Re: County Department of Parks and Recreation

Thank you for forwarding a copy of the February 23, 2011 letter from Mr. Rusinek, on behalf of the Pala Band of Mission Indians (Pala Band), for review and comment by Gregory Canyon, Ltd. (GCL), the project applicant.

**Table 2  
Gregory Canyon JTD/SWFP Application Inconsistencies and Other Comments  
(Continued)**

Figure 1.

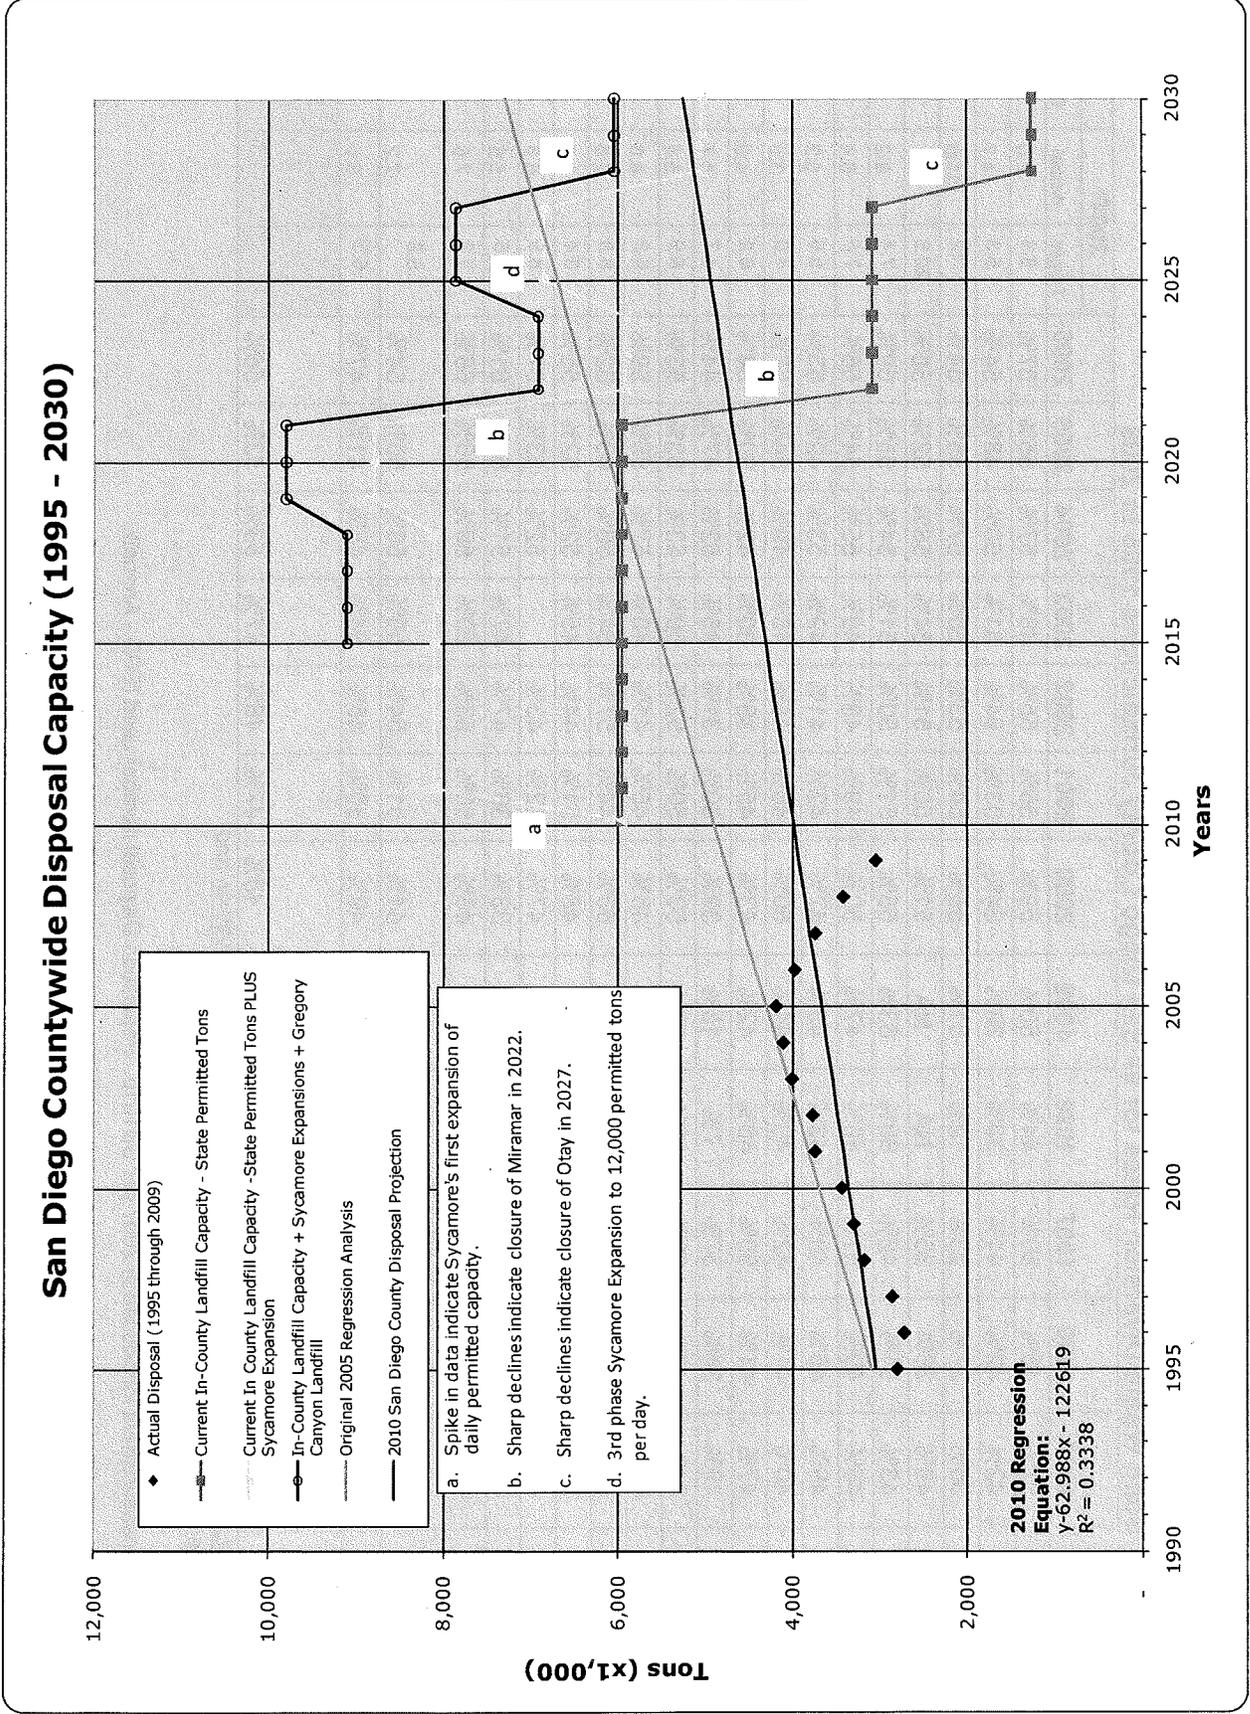
**PROCOPIO Comment 7:** In the 2005 Report, the proposed Gregory Canyon landfill was listed as a "proposed" site based on the passage of the 1994 initiative, and it was used in calculating future landfill capacity. On the other hand, in the 2010 Report, the proposed East Otay Landfill, approved by voters in 2010, is identified as a "proposed" new disposal facility but is not included in the capacity calculations provided in Figure 1. Our understanding is that the East Otay facility could provide up to 140 millions tons of capacity, and it is not clear why it is treated differently in the 2010 analysis.

**County Response to PROCOPIO Comment 7:** When the 2005 Siting Element was prepared, there was available information about Gregory Canyon, including a project description and planned operational date. Figure 1 in this update still includes Gregory Canyon Landfill, with a first year of operation based on the phase of its current permit process although the operational year is an estimate. Proposition A required that East Otay be included as a proposed landfill, however as of the date of this report update, there is no submitted project description for the East Otay Mesa proposed landfill, nor is there any estimate from officials regarding when it would open. Therefore there is no factual basis for placing it in figure 1.
